September 7, 1984

HOPE CREEK GENERATING STATION
DOCKET NO. 50-354
DRAFT SAFETY EVALUATION REPORT
OPEN ITEM STATUS

Attachment 1 is a current list which provides a status of the open items identified in Section 1.7 of the Draft Safety Evaluation Report (SER). Items identified as "complete" are those for which PSE&G has provided responses and no confirmation of status has been received from the staff. We will consider these items closed unless notified otherwise. In order to permit timely resolution of items identified as "complete" which may not be resolved to the staff's satisfaction, please provide a specific description of the issue which remains to be resolved.

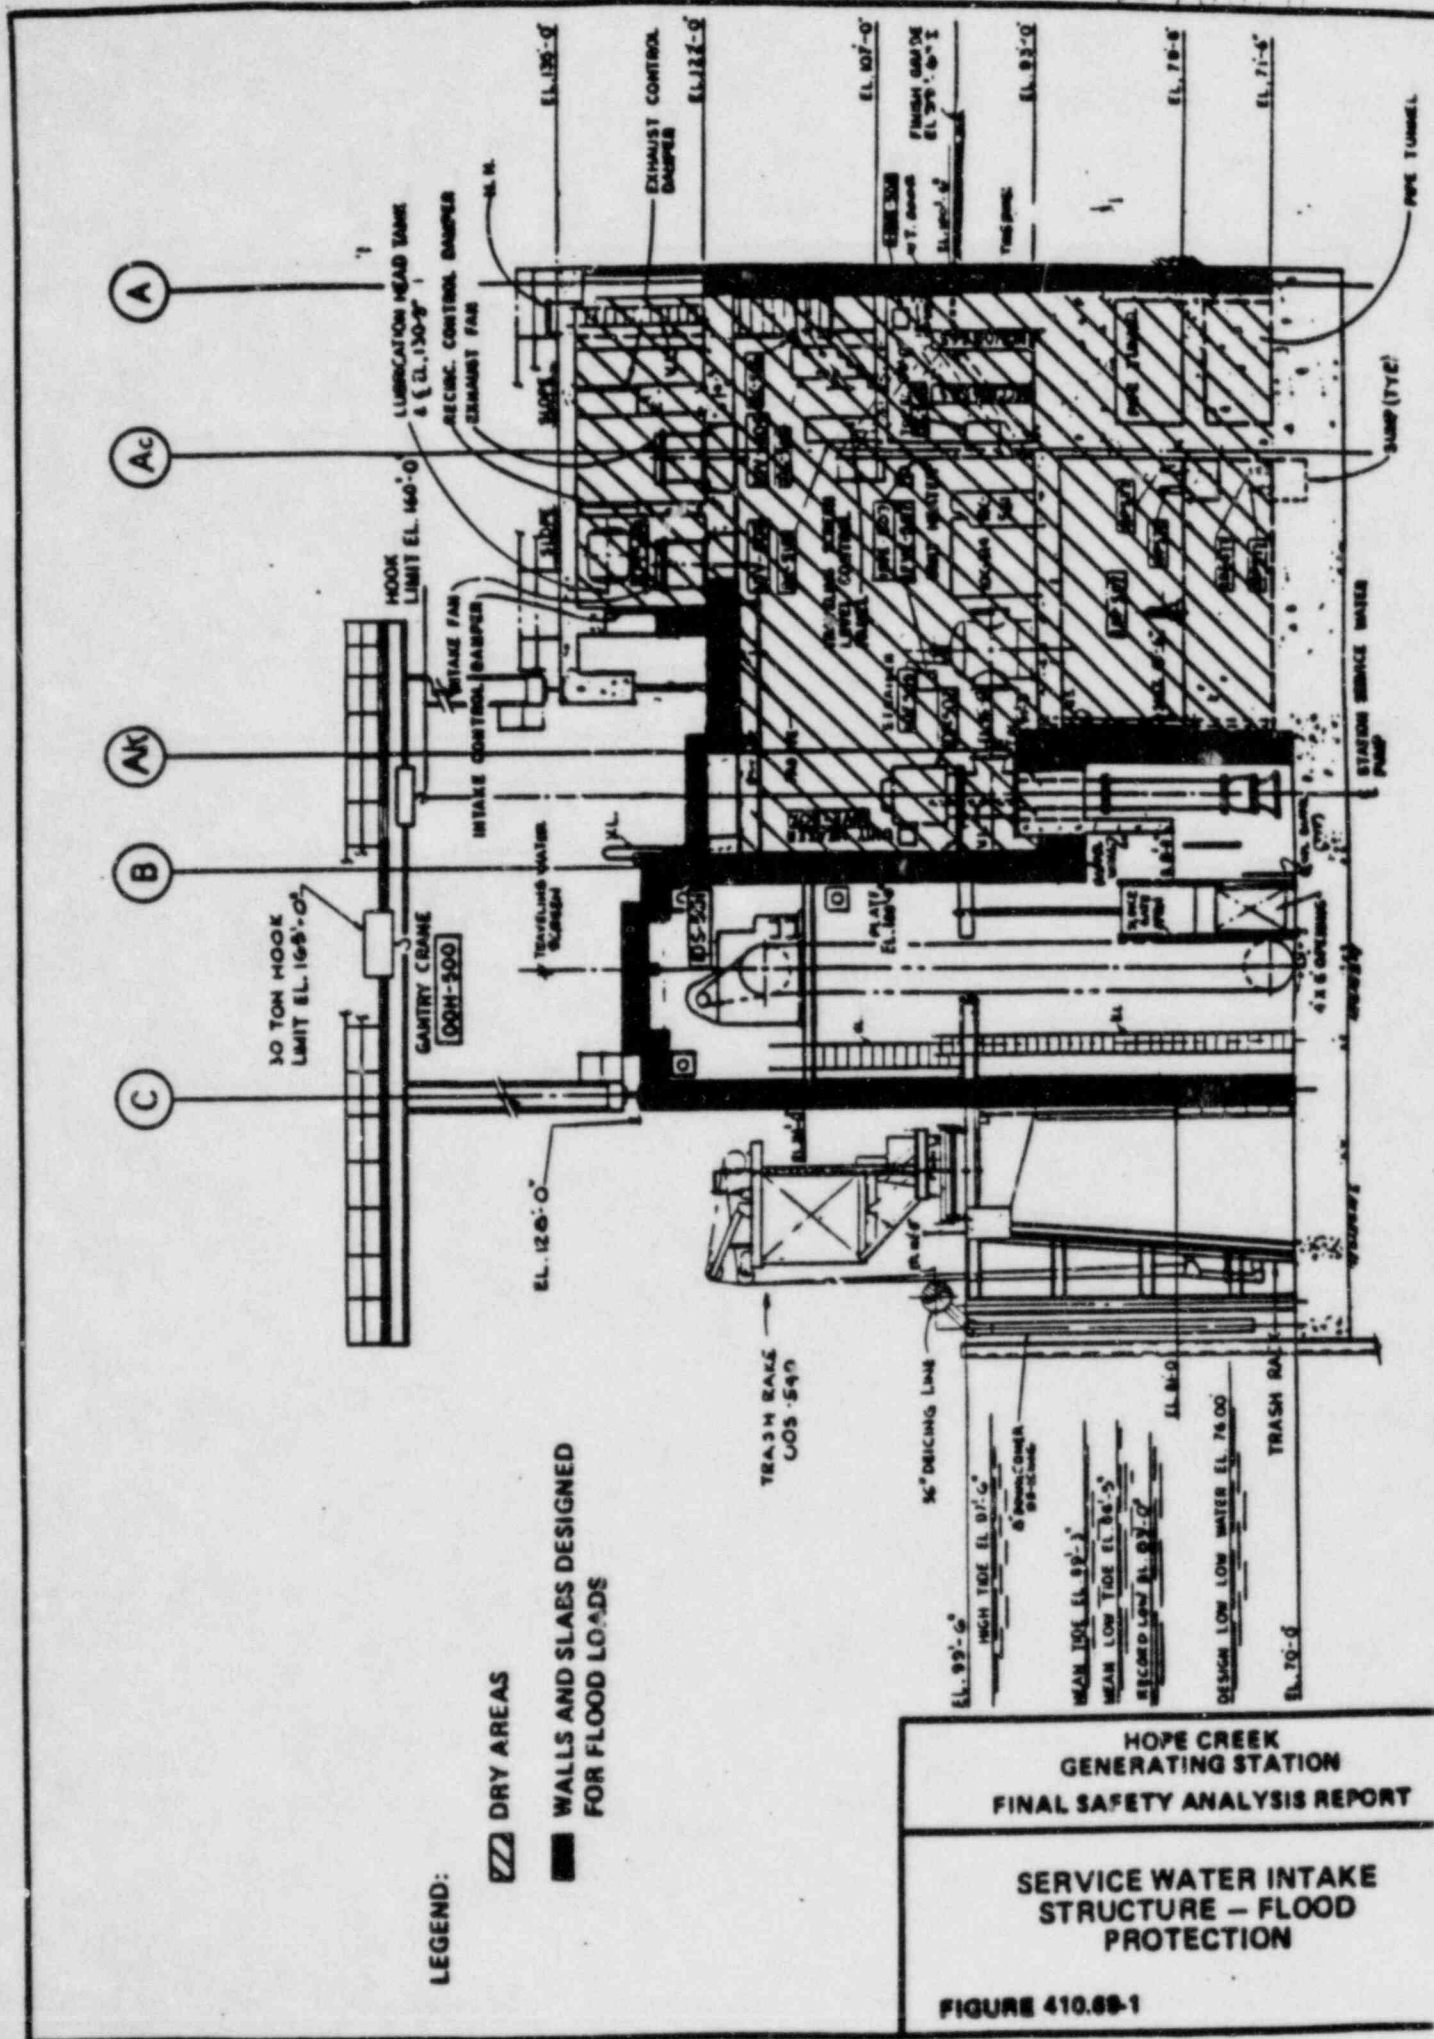
The general arrangement of the intake structure is provided in Figures 1.2-40 and 1.2-41. Section AA of Figure 1.2-41 is reproduced here as Figure 410.69-1 which identifies the water-tight areas and the walls and slabs designed to accommodate flood loads. As described in Sections 2.4.2 and 2.4.5, the south and west exterior walls of the intake structure are subject to a maximum wave run-up elevation of 134.4 feet due to the probable maximum hurricane (PMH). Such waves could overtop the roof of the western portion of the structure at elevation 128 feet. However, a rigorous analysis has been performed to determine the depth of water in the low area (elevation 122.0 feet) after wave impact and to confirm that water does not enter the building through the air intake control dampers (bottom elevation 128.5 feet). Therefore, flood water will not enter into the dry area of the intake structure. On the north side of the intake structure, the maximum water level will be only slightly higher than the still water elevation (113.8 feet) during the PMH. According to Table 2.4.6, the maximum wave elevation for the north side of the intake structure is 26.3 feet MSL (elevation 115.3 feet) due to a postulated multiple dam break. Therefore, flood protection of the north exterior wall to elevation 121.0 feet is adequate.

On the east side of the intake structure, the maximum wave run-up elevation due to the PMH equals 122.3 feet. This elevation is due to a 18 wave traveling in the direction of Fetch "A". Fetch A, which is rotated about 15 degrees from Fetch 1 (as shown in Figures 410.69-2 and 410.69-3), is chosen to maximize the wave run-up elevation. Elevation 122.3 feet exceeds the elevation of the bottom of the HVAC exhaust openings at elevation 122.0 feet by 0.3 feet. Curbs will be added at the bottom of these openings to prevent water from entering into the building.

- c. All Seismic Category I components except for the traveling water screens are located within the dry areas of the structure.
- d. The traveling water-screens, located in the "wet" area between column lines B and C have electric motors which are fully protected against the flood water level.
- e. A condition was postulated where suspended moisture enters the dry areas of the structure through the air intake control dampers. It has been assessed that all of the Seismic Category I components subjected to this environment will continue to function as required.

FIGURE 9.1-20 Sheet 1 of 2

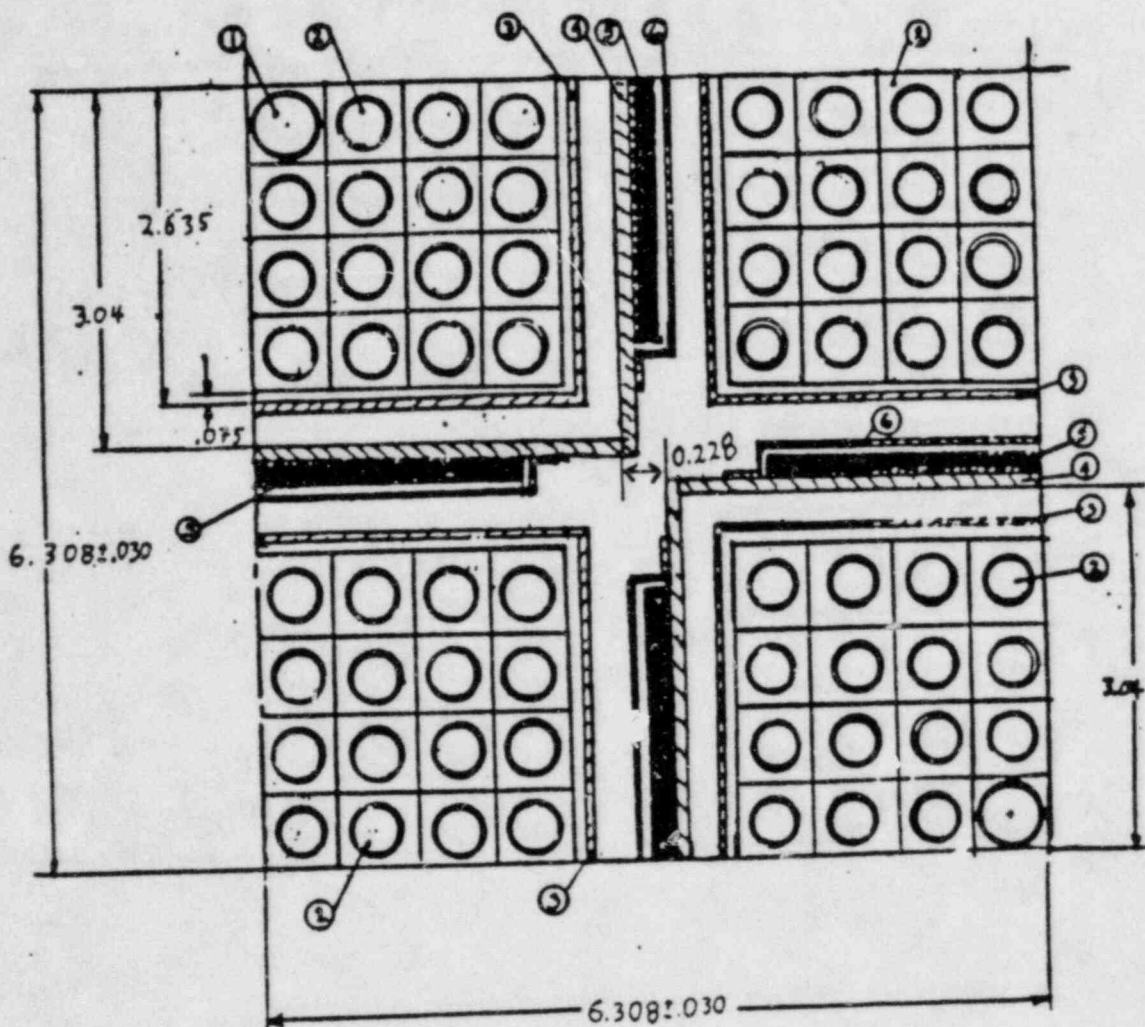
The criticality analysis was performed using the input parameters contained in Table 9.1-19. Figure 9.1-20 shows the reference geometry used in the criticality analysis, ~~the zero flux boundary and~~ the postulated dropped fuel assembly.

P-0046-1, REV 12
 HOPE CREEK
 GENERATING STATION
 FINAL SAFETY ANALYSIS REPORT
 EQUIPMENT LOCATION
 REACTOR BUILDING
 PLAN EL. 162'-0" & EL. 178'-6"
 FIGURE 1.2-31

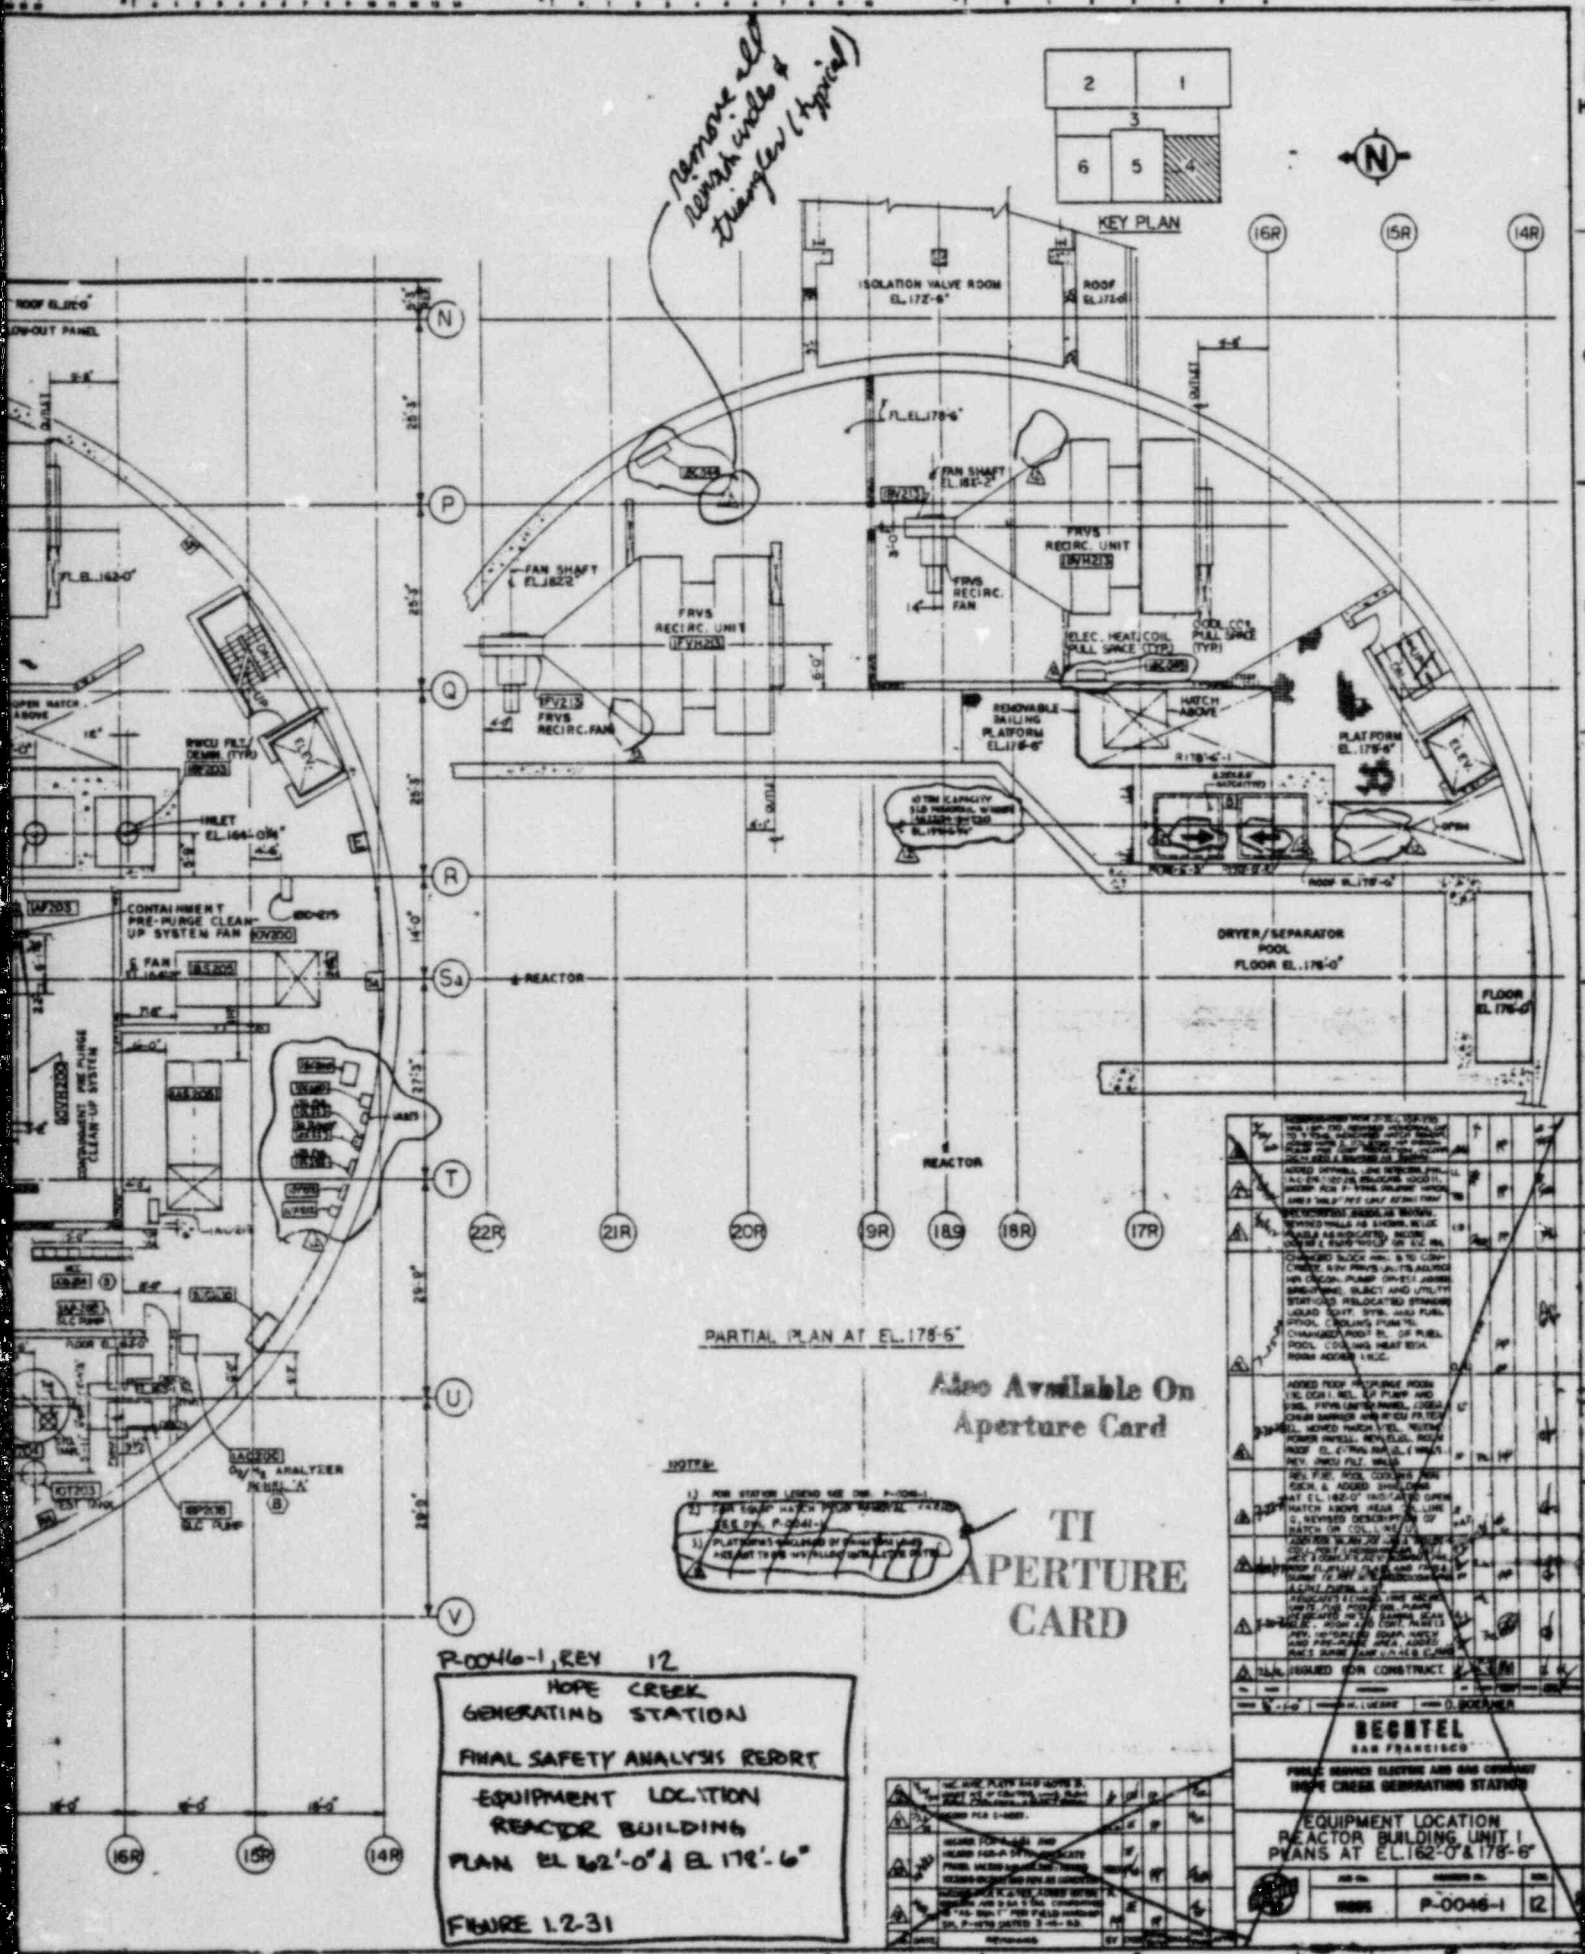
Remove all Wash water & Triangles (typical)
